D.6.2.4

Proposed Revision to ACI 318-02 Appendix D:

Fig. RD.6.2.4 - Shear in narrow ($c_{2,max} < 1.5c_1$), thin ($h < 1.5c_1$) members

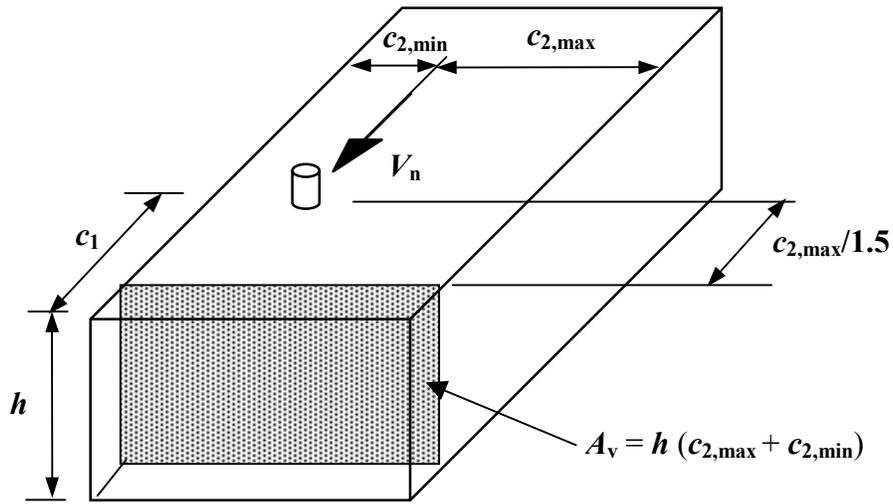
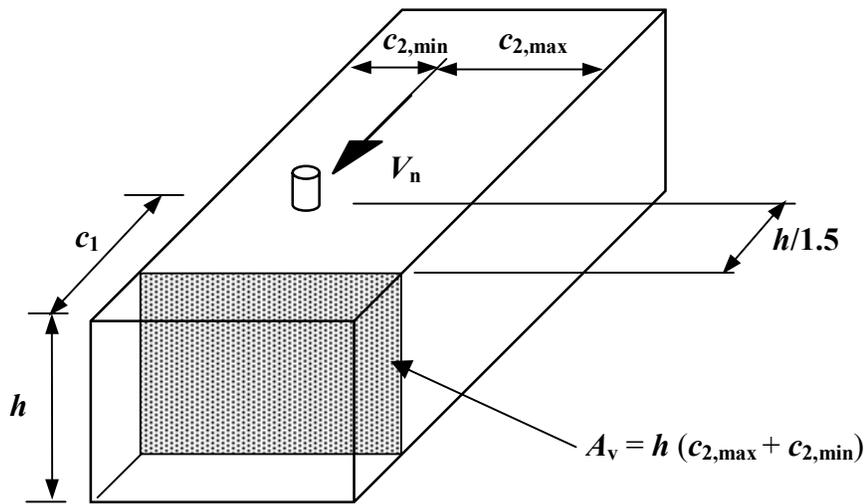
Section D.6.2.4 of ACI 318-02 deals with a very unusual condition where the shear is directed toward a free edge but there are two other close edges perpendicular to the applied load and the member thickness is less than 1.5 times the edge distance that the shear is directed toward. Although an infrequent occurrence, the current wording of D.6.2.4 has caused concern and rightly so. There was a change back in 1997 that dropped a term from this section unintentionally. The 1997 CB 30 wording, the proposed revision to D.6.2.4, and a possible new figure are provided below.

D.6.2.4 - For the special case of anchors in a narrow ($c_{2,max} < 1.5c_1$), thin ($h < 1.5c_1$) member influenced by three or more edges, the edge distance c_1 used in Eq. (D-22), (D-23), (D-24), (D-25), (D-26) and (D-27) shall be limited to $c_{2,max}/1.5$ if $c_{2,max} > h$ or $h/1.5$ if $c_{2,max} < h$.

RD.6.2.4 – For anchors in a narrow ($c_{2,max} < 1.5c_1$), thin ($h < 1.5c_1$) member influenced by three or more edges where any edge distance is less than $1.5e_1$, the shear breakout strength computed by the basic CCD Method, which is the basis for Eq. (D-23) and (D-24), gives safe but misleading results. These special cases were studied for the κ Method^{D.14} and the problem was pointed out by Lutz^{D.20}. Similar to the approach used for tensile breakouts in D.5.2.3, a correct evaluation of the capacity is determined if the value of c_1 to be used in Eq. (D-22) to (D-27) is limited to $c_{2,max}/1.5$ if $c_{2,max} > h$ or $h/1.5$ if $c_{2,max} < h$. This is shown in Fig. RD.6.2.4.

$c_{2,max} > h$: Use $c_{2,max} / 1.5$ for c_1 in Eq. (D-22) to (D-27)

$c_{2,max} < h$: Use $h/1.5$ for c_1 in Eq. (D-22) to (D-27)
